## SAE proposal for improvement of “lane keeping assist warning” display

#### A. New Supplement to the 06, 07 and 08 series of amendments to UN Regulation No. 48

##### Symbols and patterns for the use as Driver Assistance Projections and Explanations of the Warnings/Highlights

Photos taken during demonstration of Maybach vehicle at GRE-82 (23 October 2019)

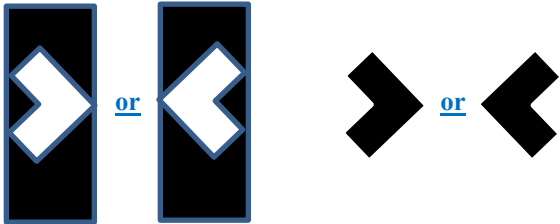
1. With reference to the lane keeping assist warning it is SAE's understanding that the intent of this warning is to allow the driver to make a gradual (smooth) manoeuvre instead of an abrupt one. To achieve this, the warning shall be provided in advance, when the vehicle **is about to** exit the lane (before it crosses the lane marking), as opposed to when the vehicle has exited its lane (started crossing or has crossed the lane marking). This appeared to be the case during the GRE demo in October 2019 (see photos below), where projections were activated when the vehicle was still in its lane. Moreover, a situation could occur where there is no road surface to project on, if the projection were activated in case the vehicle exits its lane, as could be the case for the exit towards the right, like the one during the GRE-82 demonstration.
